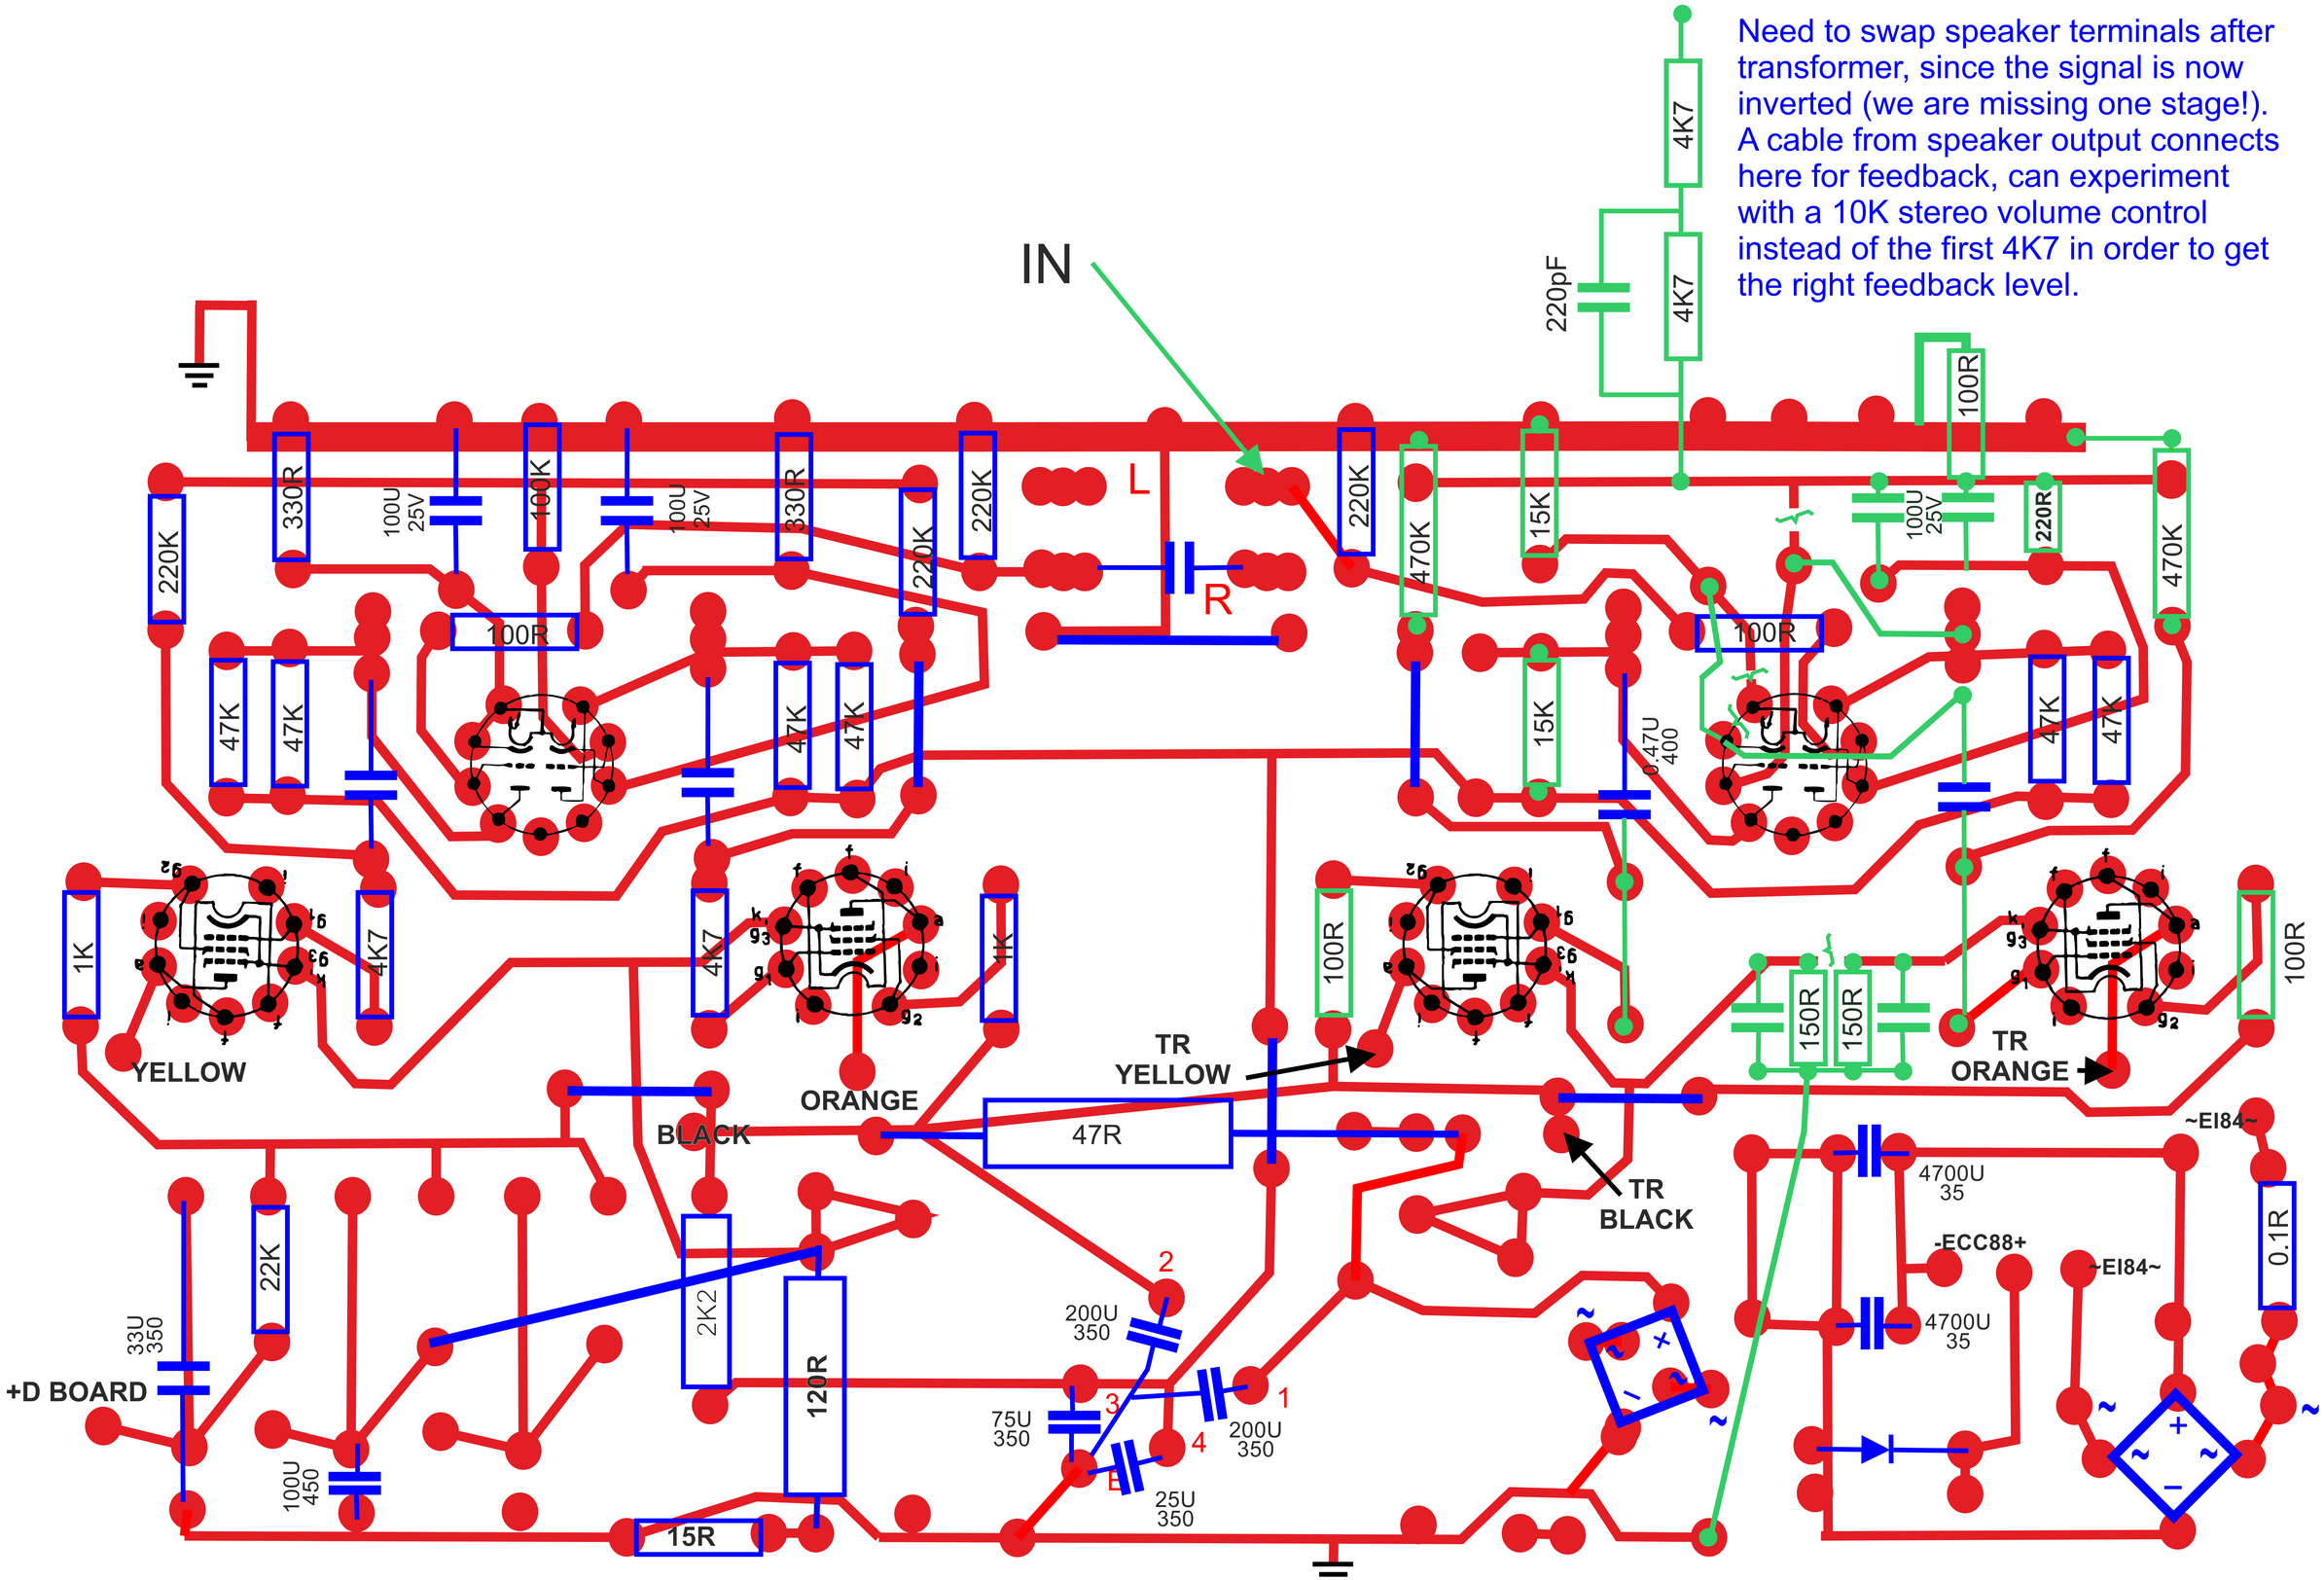
Need to swap speaker terminals after transformer, since the signal is now inverted (we are missing one stage!). A cable from speaker output connects here for feedback, can experiment with a 10K stereo volume control instead of the first 4K7 in order to get the right feedback level.
IN
L
R
220K
330R
100U 25V
100K
100R
47K
1K
4K7
220pF
470K
15K
0.47U 400
220R
150R
47R
YELLOW
ORANGE
BLACK
TR YELLOW
TR BLACK
TR ORANGE
~EI84~
-ECC88+
4700U 35
0.1R
22K
2K2
120R
15R
33U 350
+D BOARD
100U 450
200U 350
75U 350
25U 350
1
2
3
4
